# UNITED STATES DEPARTMENT OF THE INTERIOR BUREAU OF LAND MANAGEMENT

1. Type of Well Gas Well Other					8. Well Name and No. MERLYN 27-22 FEDERAL 2H			
2. Name of Operator Contact: TRINA C DEVON ENERGY PRODUCTION CO ERMail: trina.couch@dvn.com					9. API Well No. 30-015-42386-00-X1			
3a. Address 333 WEST SHERIDAN AVE OKLAHOMA CITY, OK 73102	3b. Phone No. (include area code) Ph: 405-228-7203		10. Field and Pool, or Exploratory LOST TANK

## PECOS DISTRICT CONDITIONS OF APPROVAL

WELL NAME & NO.: | Merlyn 27-22 Fed 2H

K. TAHA 05-08-13 DRAWING NUMBER R. HAMILTON 05-08-13 DM 00161771-2A

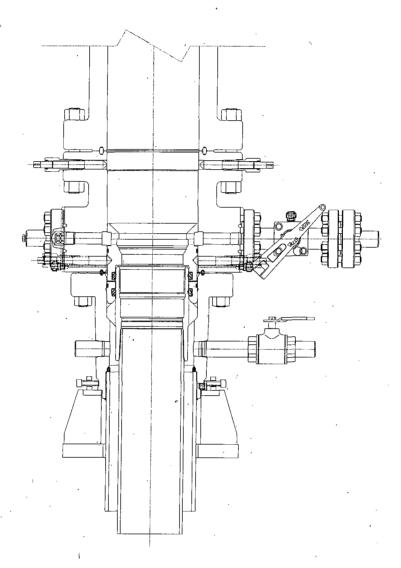
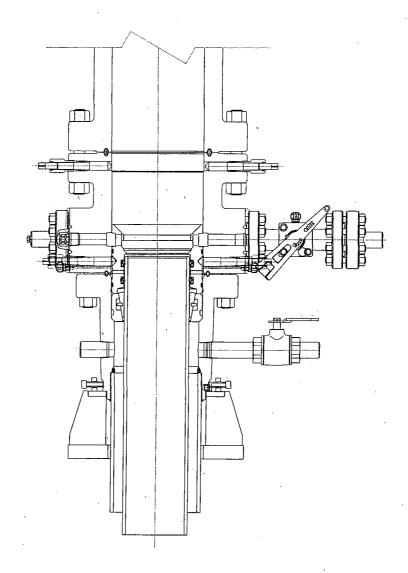
Devon proposes using a multi-bowl wellhead assembly (FMC Uni-head). This assembly will only be tested when installed on the surface casing. Minimum working pressure of the blowout preventer (BOP) and related equipment (BOPE) required for drilling below the surface casing shoe shall be 3000 (3M) psi

- Wellhead will be installed by FMC's representatives.
- If the welding is performed by a third party, the FMC's representative will monitor the temperature to verify that it does not exceed the maximum temperature of the seal.

- FMC representative will install the test plug for the initial BOP test.
- FMC will install a solid steel body pack-off to completely isolate the lower head after cementing intermediate casing. After installation of the pack-off, the pack-off and the lower flange will be tested to 5M, as shown on the attached schematic. Everything above the pack-off will not have been altered whatsoever from the initial nipple up. Therefore the BOP components will not be retested at that time.

- If the cement does not circulate and one inch operations would have been possible with a standard wellhead, the well head will be cut and top out operations will be conducted.

- Devon will pressure test all seals above and below the mandrel (but still above the casing) to full working pressure rating.
- Devon will test the casing to 0.22 psi/ft or 1500 psi, whichever is greater, as per Onshore Order #2.

- 3. Operator has proposed a multi-bowl wellhead assembly. This assembly will only be tested when installed on the surface casing. Minimum working pressure of the blowout preventer (BOP) and related equipment (BOPE) required for drilling below the surface casing shoe shall be 3000 (3M) psi.

- a. Wellhead shall be installed by manufacturer's representatives, submit documentation with subsequent sundry.
  - b. If the welding is performed by a third party, the manufacturer's representative shall monitor the temperature to verify that it does not exceed the maximum temperature of the seal.

- c. Manufacturer representative shall install the test plug for the initial BOP test.
  - d. Operator shall perform the intermediate casing integrity test to 70% of the casing burst. This will test the multi-bowl seals.

- e. If the cement does not circulate and one inch operations would have been possible with a standard wellhead, the well head shall be cut off, cementing operations performed and another wellhead installed.
